ADDENDUM NO. 2

March 1, 2022

**TIMOTHY BALL ELEMENTARY SCHOOL ADDITIONS, RENOVATIONS,
AND RELATED WORK
Crown Point, IN 46307**

This Addendum forms a part of and modifies the Bidding Requirements, Contract Forms, Contract Conditions, the Specifications, and the Drawings dated February 7, 2022 by Gibraltar Design. Acknowledge receipt of the Addendum in the space provided on the Bid Form. Failure to do so may subject the Bidder to disqualification.

A,B MV102

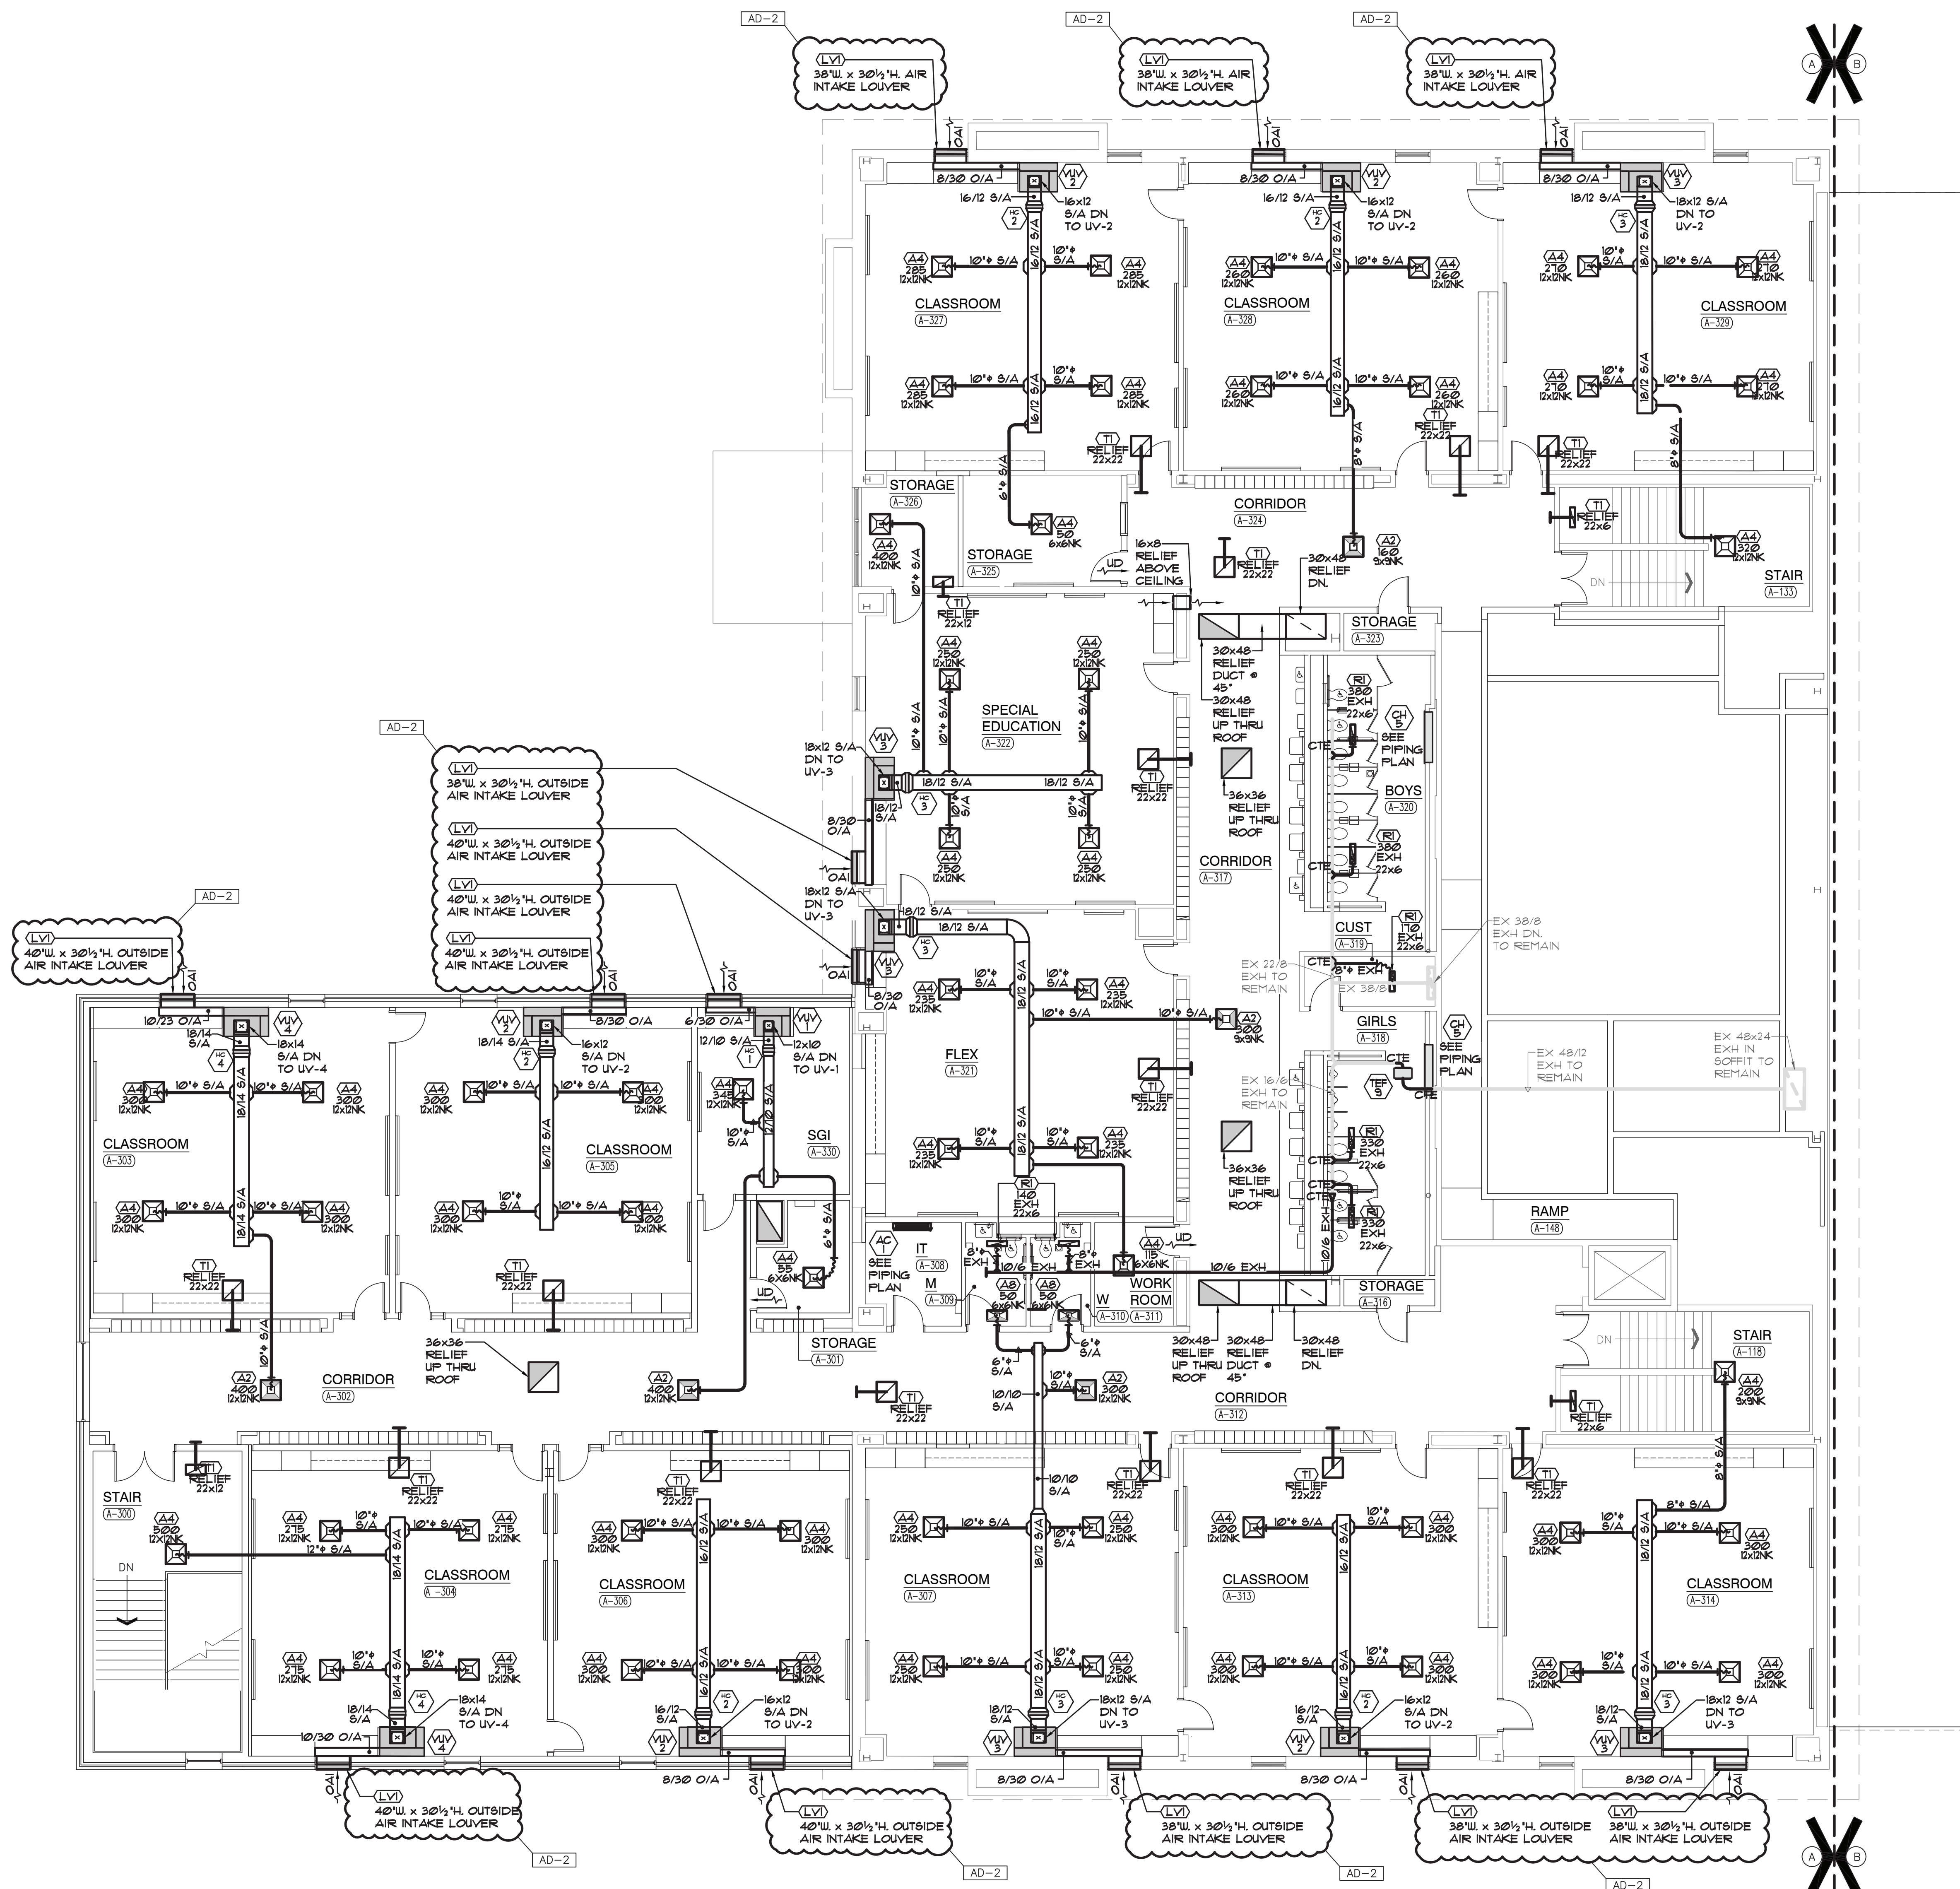
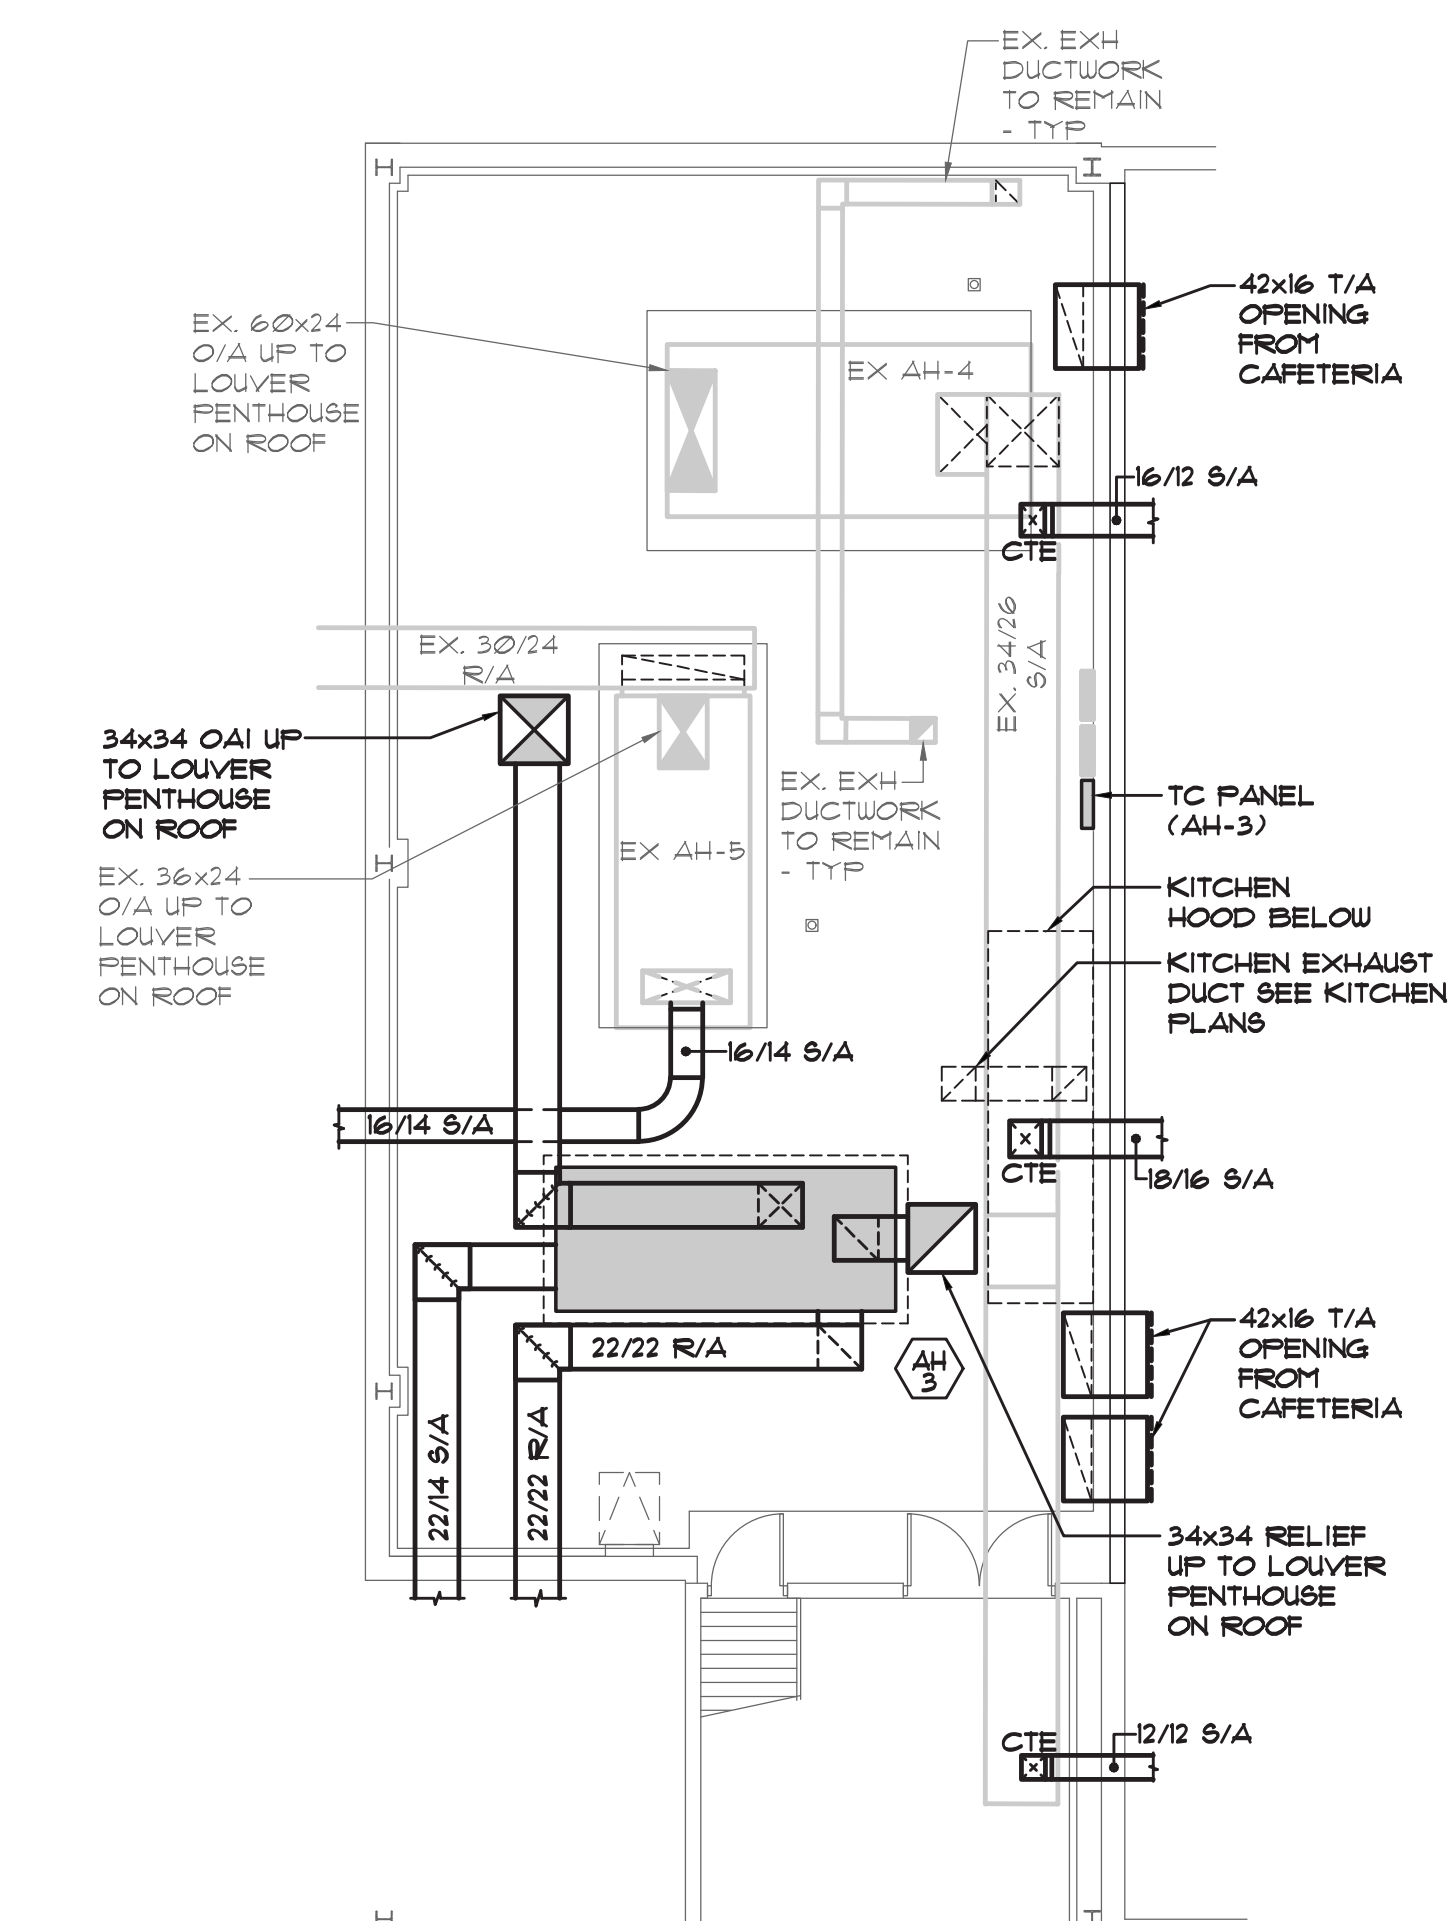
25. Sheet MV102

- A. Refer to revised, full size drawing, included in this Addendum, for the following revisions:
1. Revised louver size to 40"w x 30 ½ "h in Classroom A-303, A-304, A-305, A-306, SGI A-330, and Flex A-321.
 2. Revised louver size to 38"w x 30 ½ "h in Classroom A-307, A-313, A-314, A-327, A-328, a-329 and Special Education a-322.
